ADDENDUM NO. 3

March 4, 2011
09076.D

to the construction documents
Beacon Hill Linear Park Phase One
CIMS Project No. 2600572

C 4.1

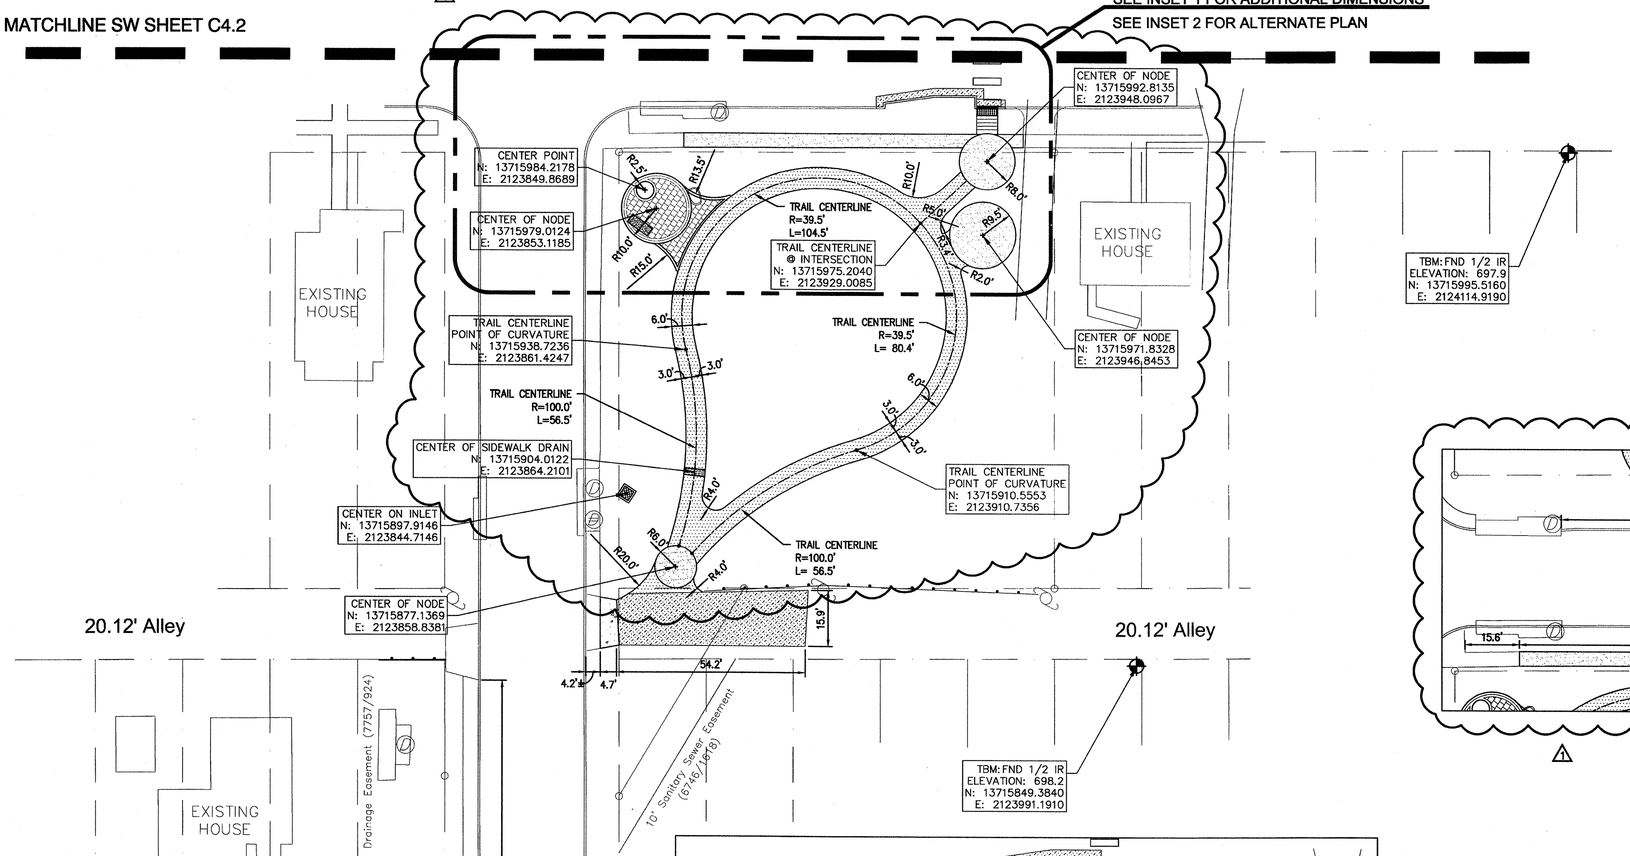
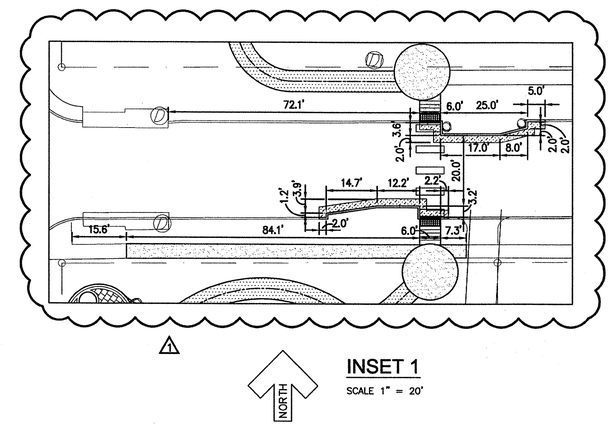
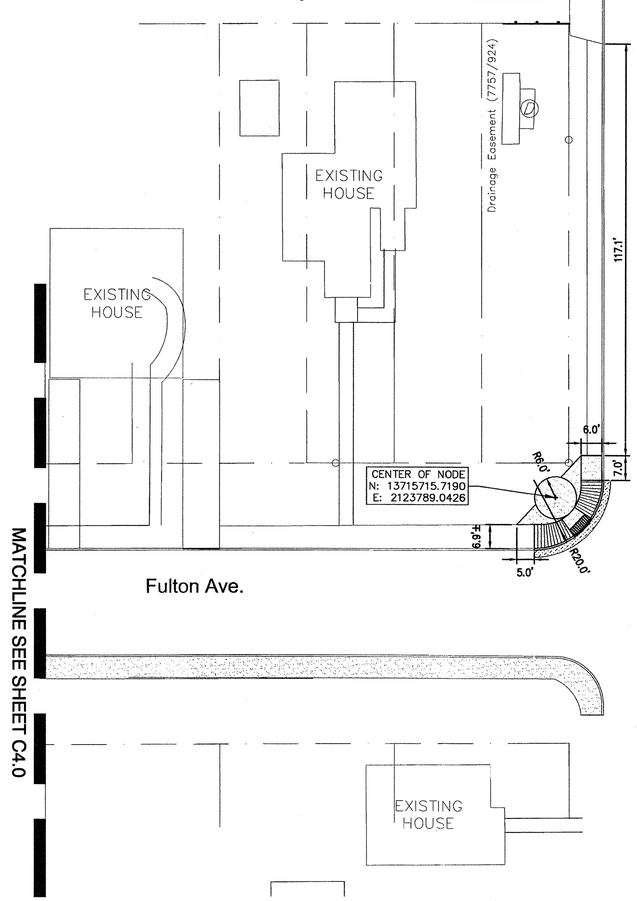
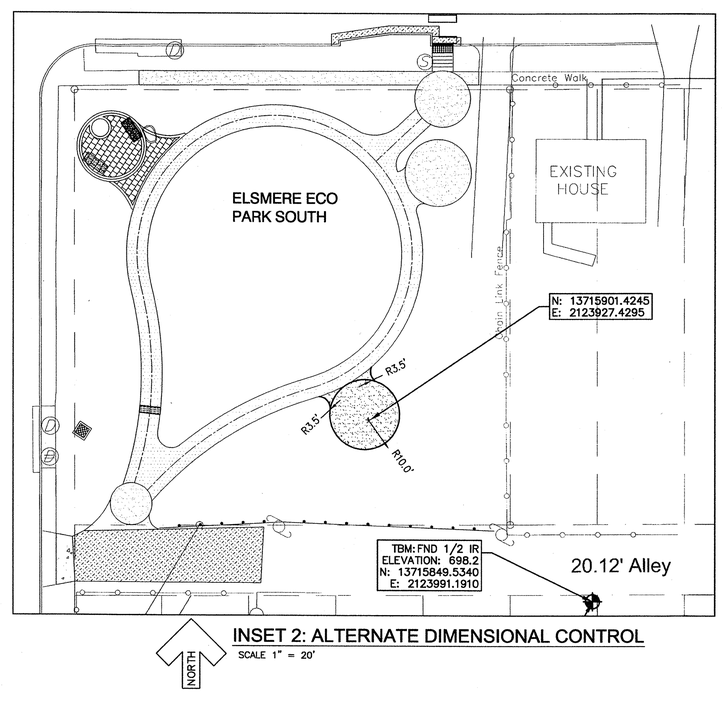
REVISION:
REVISED COORDINATES AND DIMENSIONS PER SITE CHANGES

ADDENDUM NO. 3 ATTACHMENT "L"

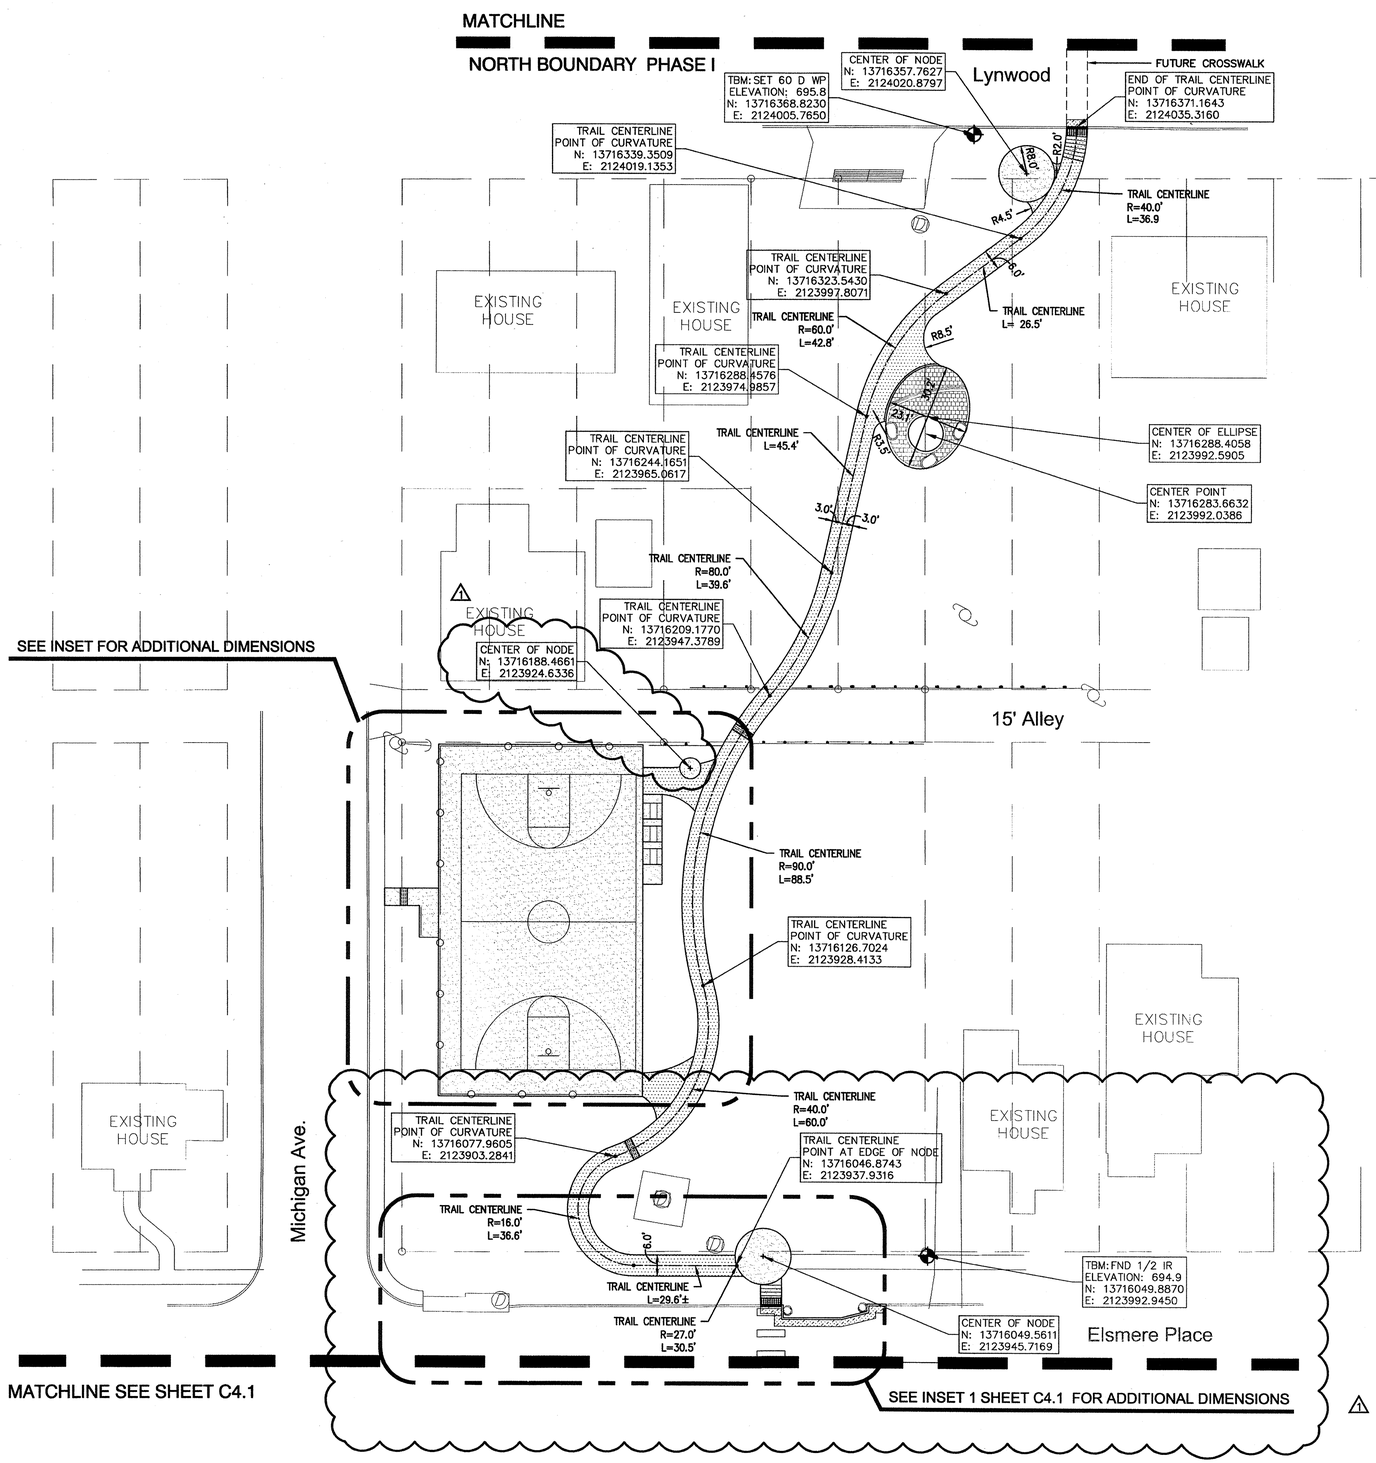
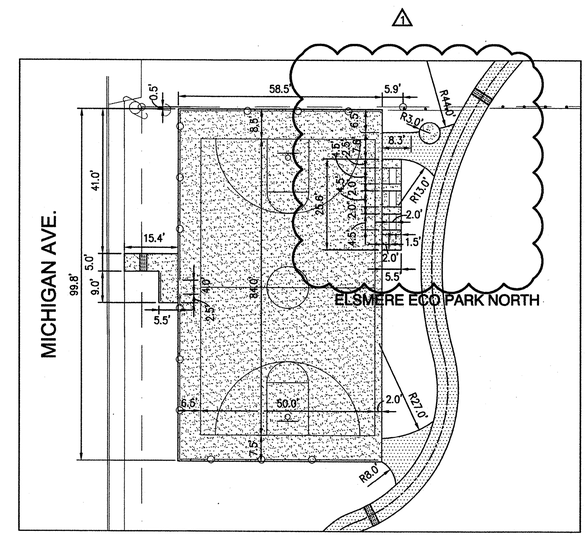
1 REVISION:
REVISED DIMENSIONS AND COORDINATES PER SITE CHANGES.

DIMENSIONAL CONTROL PLAN ALTERNATE

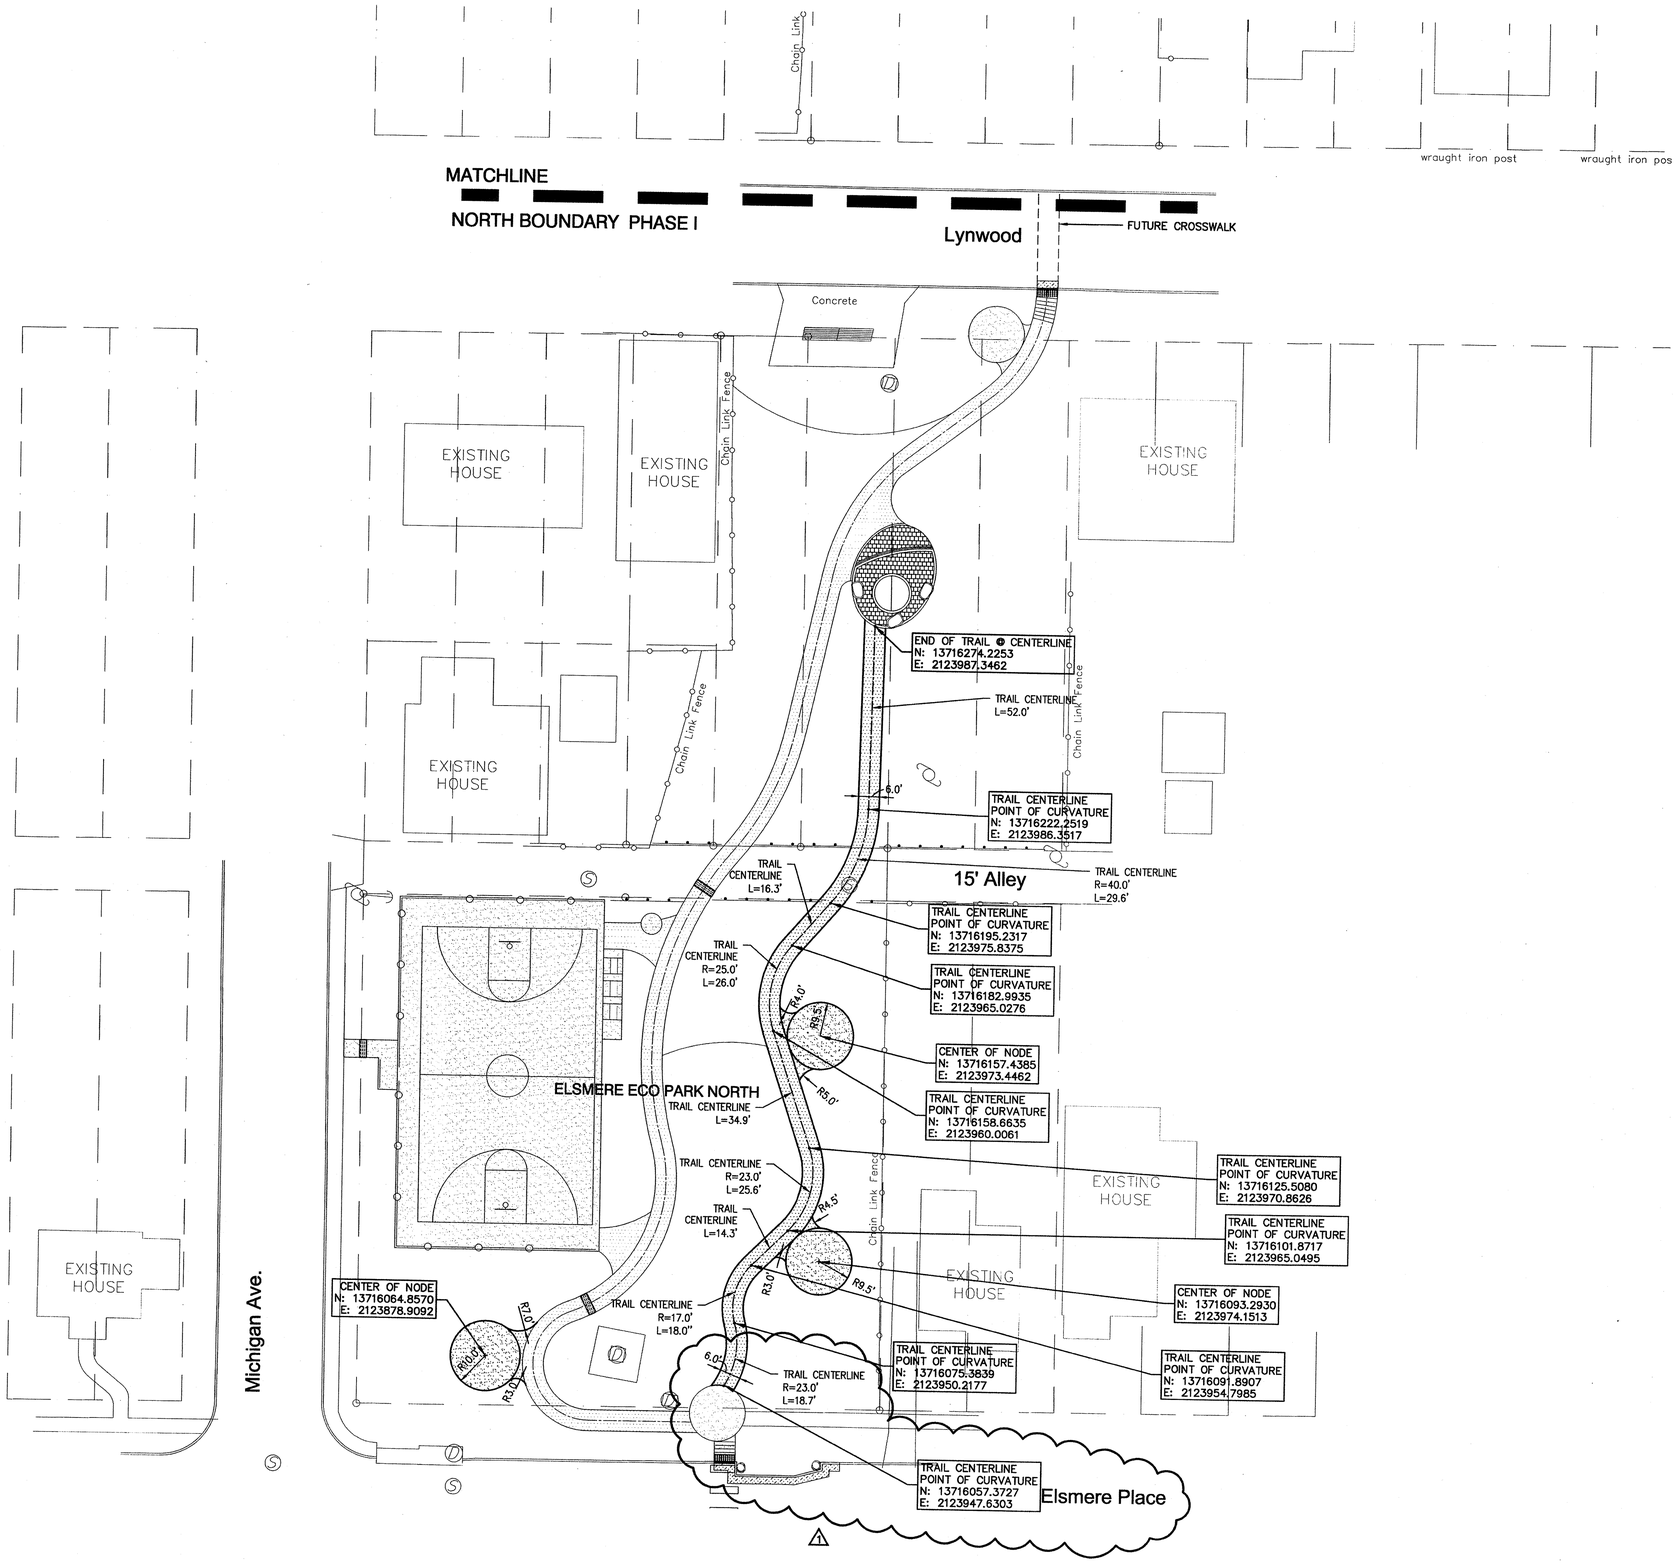
1 REVISION:
REVISED DIMENSIONS AND COORDINATES PER SITE CHANGES.

C 5.1

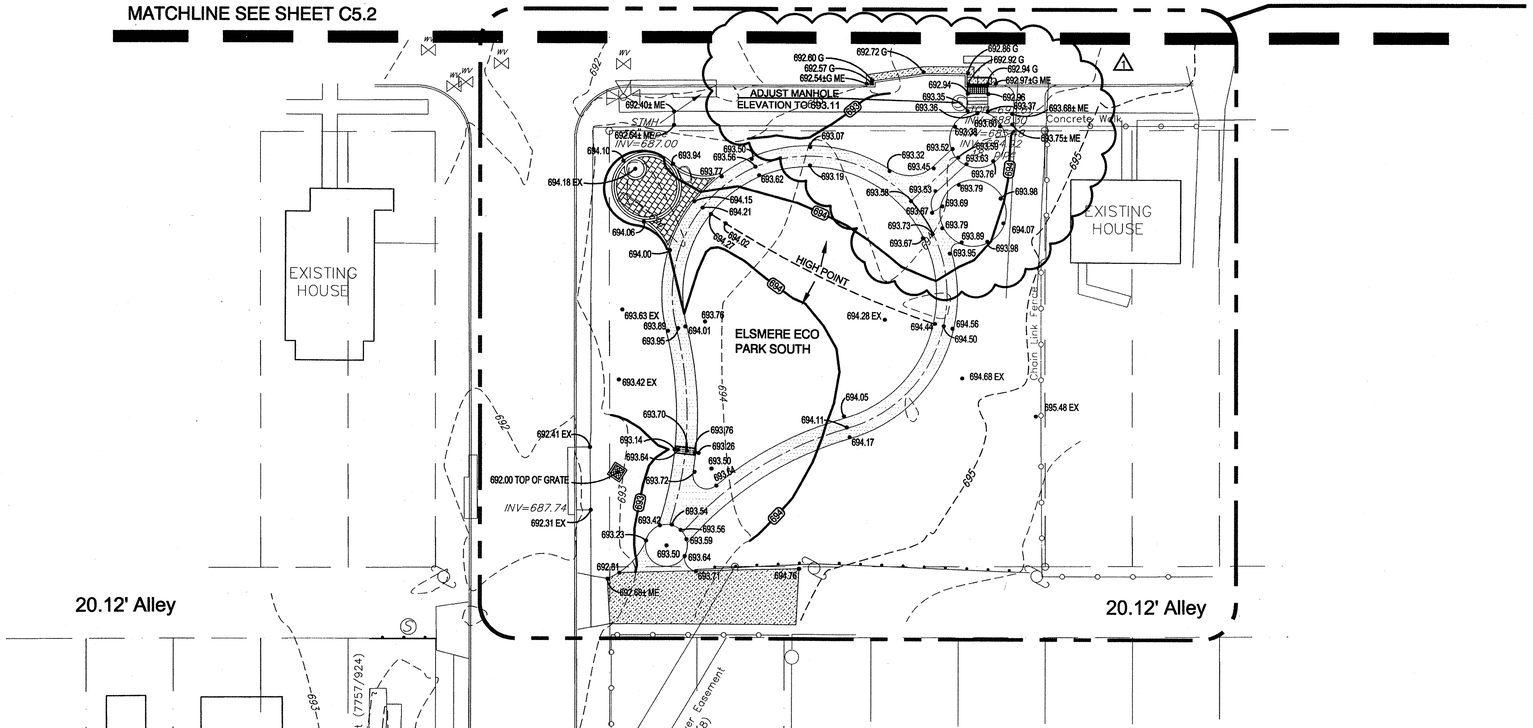
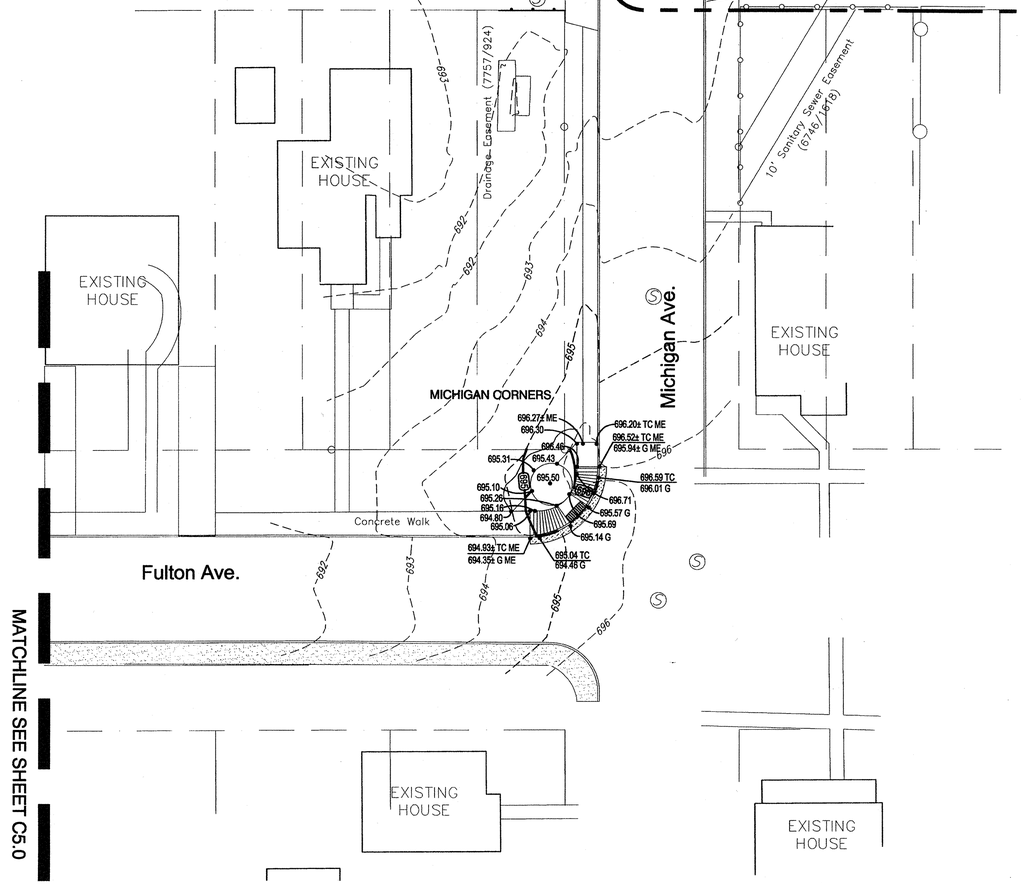
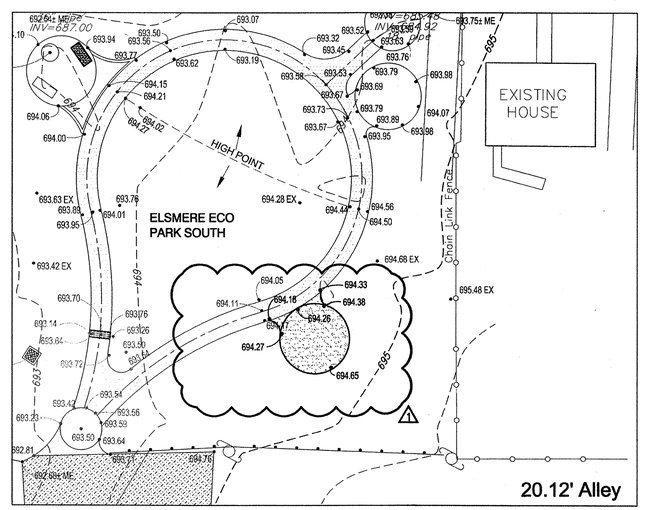
REVISION:
REVISED CONTOURS AND SPOT ELEVATIONS PER SITE CHANGES.
